# TUSCAN RIDGE

**MASTER DEVELOPMENT PLAN**  
**TUSCAN RIDGE**  
CITY OF SAN ANTONIO, BEXAR COUNTY TEXAS

**City of San Antonio**  
**Development Services Department**  
**Master Development Plan Section**  
**Technical Review**

**RE: Master Development Plan (MDP) for Tuscan Ridge Subdivision**

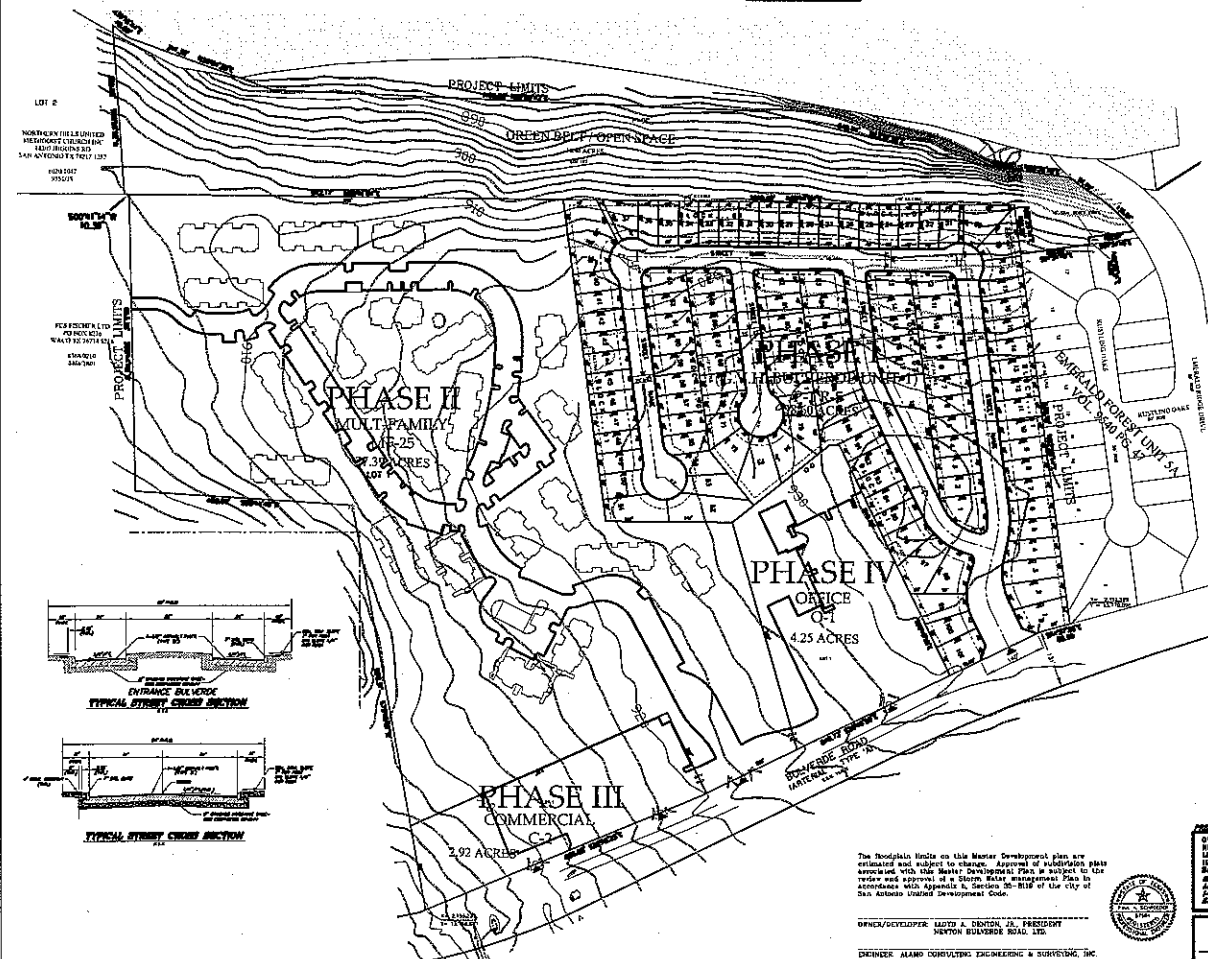
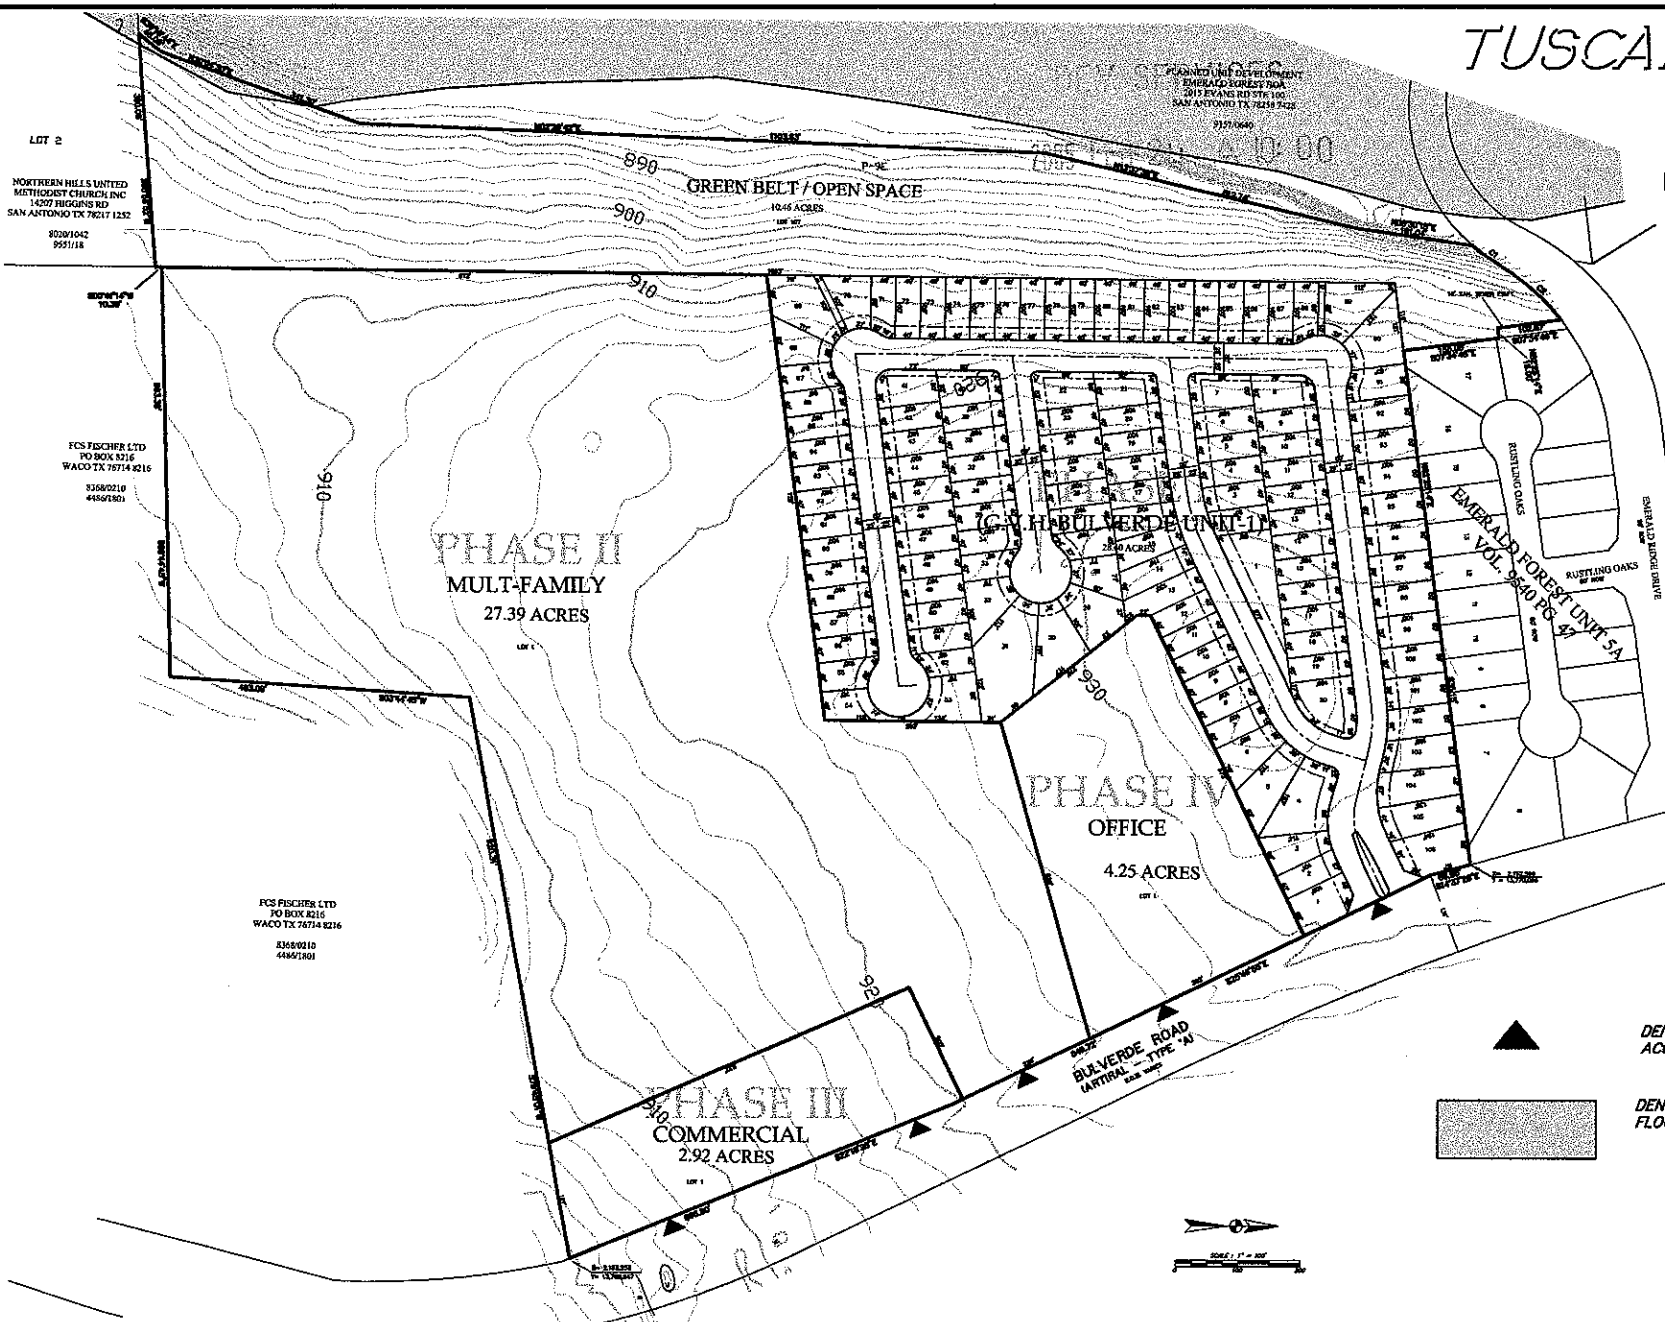
Comments: 1.) CONDENSE BOTH SHEET INTO (1) ONE SHEET.

3.) PROVIDE PROTECTION OF STREETS TO THE SOUTH OF THE PROPERTY.

6.) SHOW THE DIMENSIONS AT THE ACCESS.

1. Place a note on the plans specifying that the: Green Belt/ Open Space shall be platted with Phase I - unit 1 and Phase II at the time of Platting
2. The dimensions can not be seen at the entrance of Phase I.
3. On the legend describe what the arrows to the south of the project denote? to undeveloped property. Provide projection of Roadway to undeveloped property, as per UDC 35-506(e)(2)
4. Place dimensions on two corners of the project to Bulverde Road. The dimensions on Bulverde Road can barley be seen.

- 1. Condense both sheets into one (1) sheet.**
- 2. Label the "Project Limits" and make the line Darker.**
- 3. Provide Projection of Streets to the south of property as shown on the red lines.**
- 4. The required Connectivity Ratio is 1.2 , the MDP has 1.142 which does not the Ratio.**
- 5. Show the dimensions at the entrance of the project.**
- 6. Show the zoning on the MDP, R4 ?, MF-33 ?, C2 ?, Etc.**

### MASTER DEVELOPEMENT PLAN

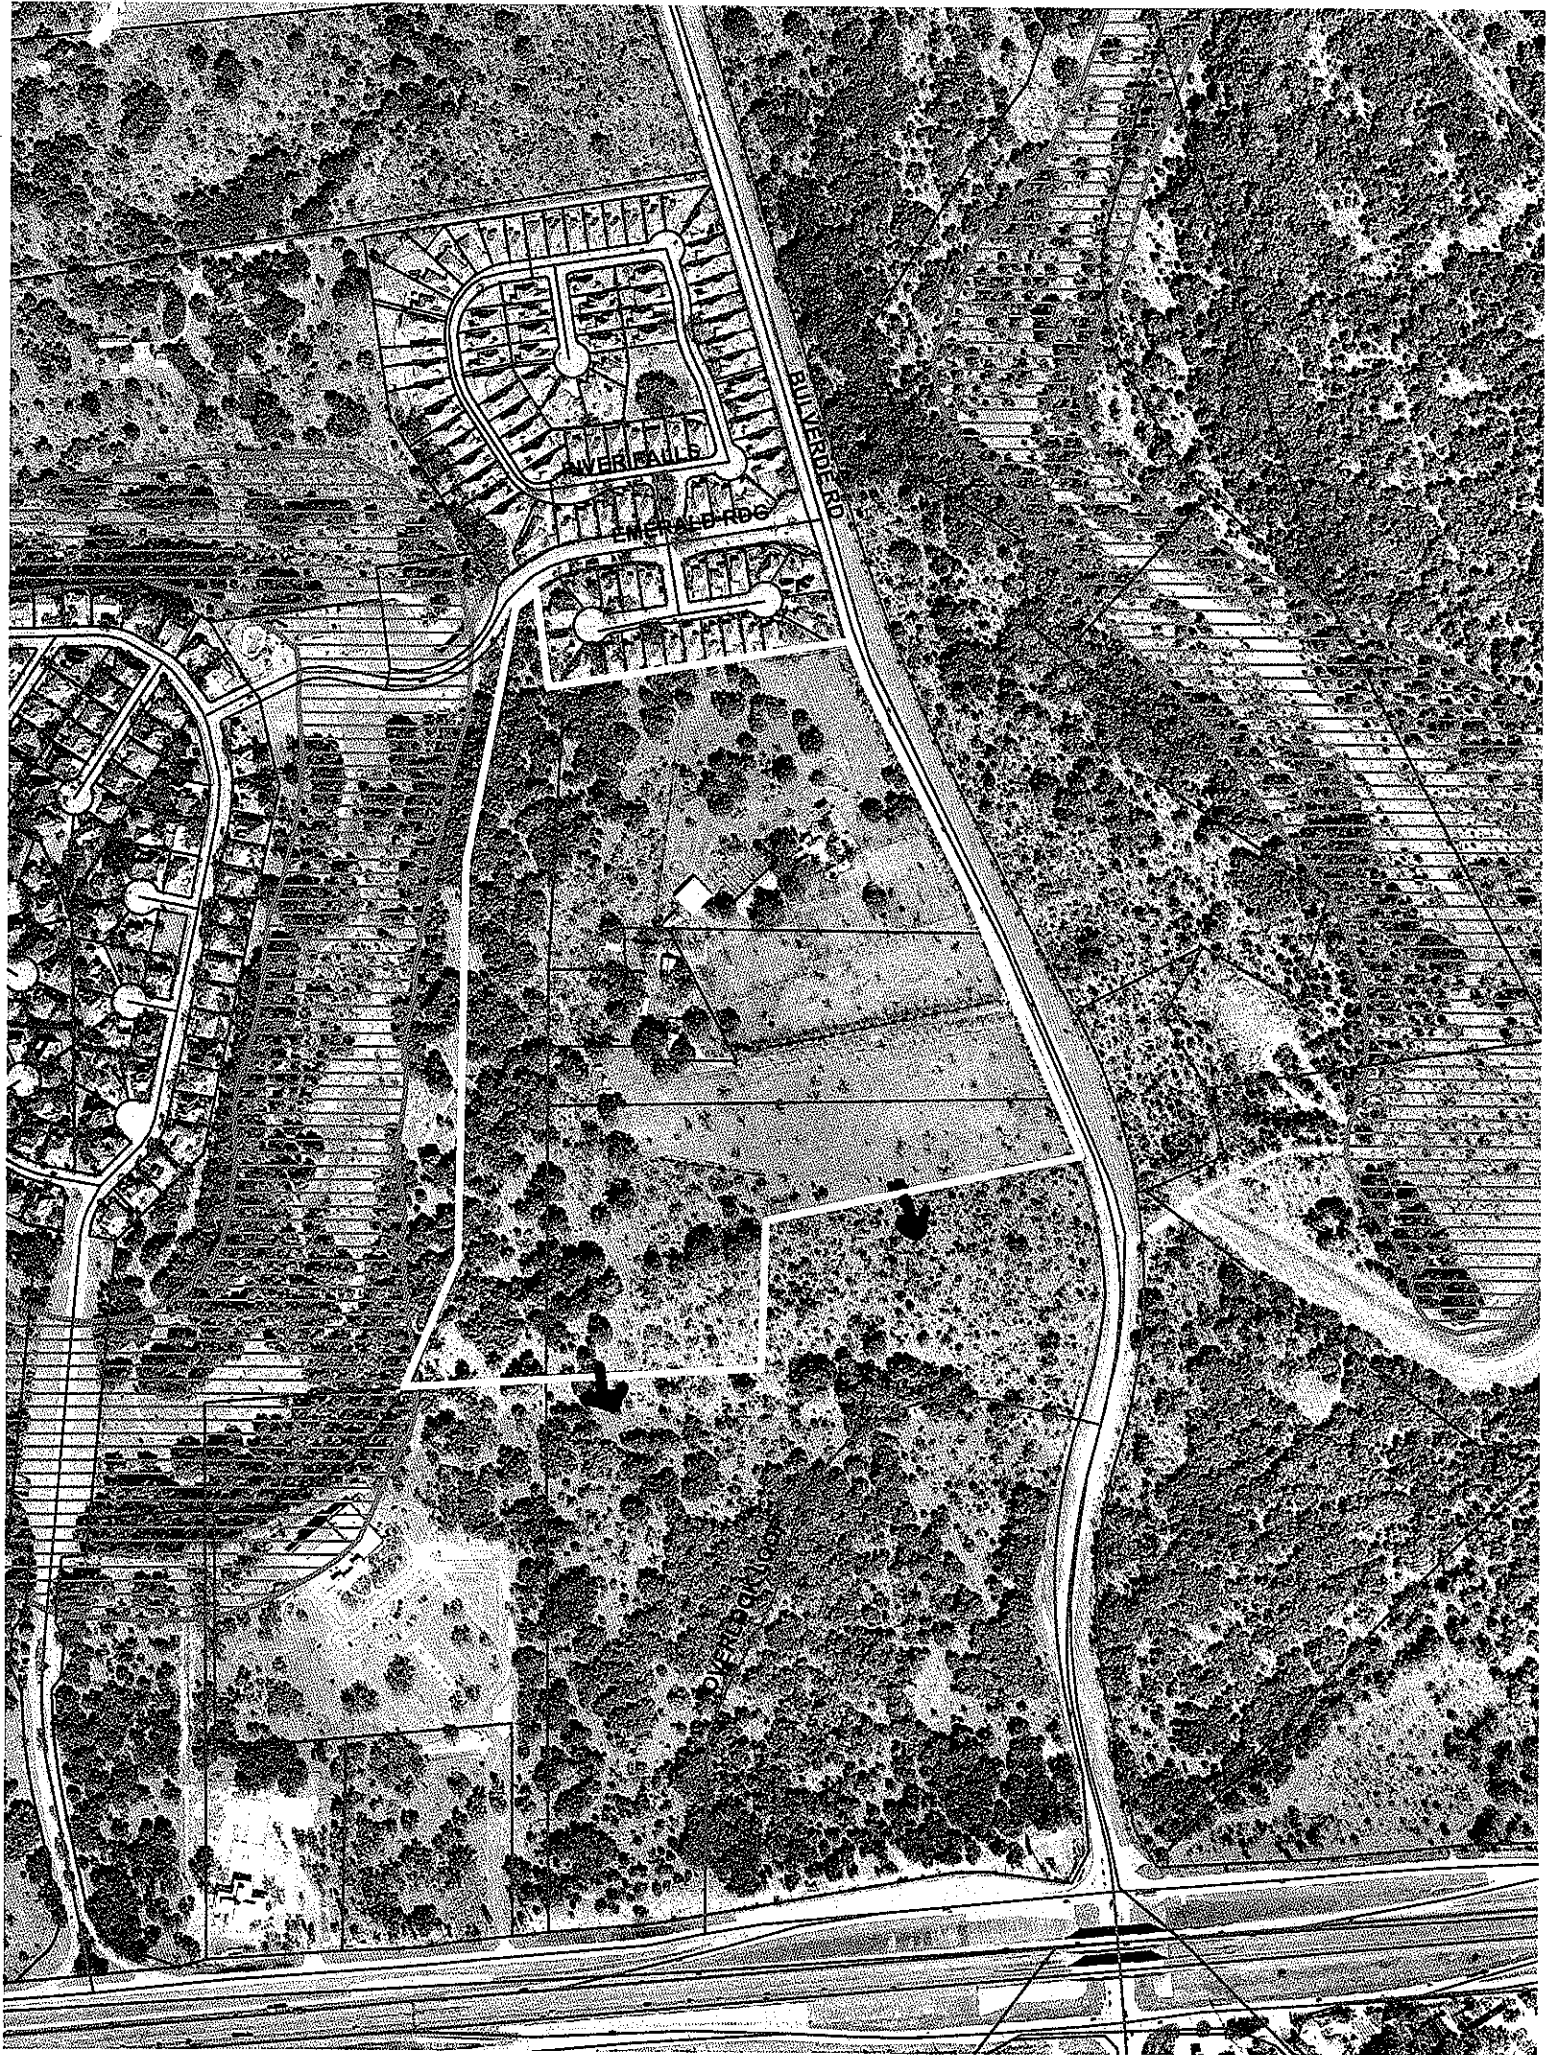
2. Clearly annotate the subject site, the drawing scale, and flow paths to a minimum of 2000-feet downstream on the submitted USGS exhibit(s).
3. Submit hydrologic runoff and hydraulic capacity calculations to show that existing and/or proposed drainage systems along these 2000-foot paths have the capacity to accept the expected 100-year ultimate development runoff from tributary areas thereto. Specifically, consider any culverts in Emerald Forest Drive as well as the capacity of Bulverde Road. For comparison, also analyze hydraulics under existing development conditions. At a minimum, analyze at least one cross-section at the 2000-foot limit in consideration of current and ultimate development conditions. Submit an off-site drainage area map.

4. Determine the limits of the 100-year floodplain adjacent to the subject site's west property line under ultimate development conditions. Provide runoff and hydraulic calculations to determine the ultimate development floodplain. Provide drainage easements to contain the larger of the 100-year ultimate development floodplain and the 25-year ultimate development floodplain plus required freeboard. (Or dedicate the Green Belt / Open Space area as a Drainage Easement.)

6. Label drainage easements on the MDP and the Master Drainage Plan. Check the direction of flow of the street near west property line. Should a portion of this street drain to the north?
7. Check the intersection of drainage Areas A, B, and D. Should this be moved toward the proposed street?
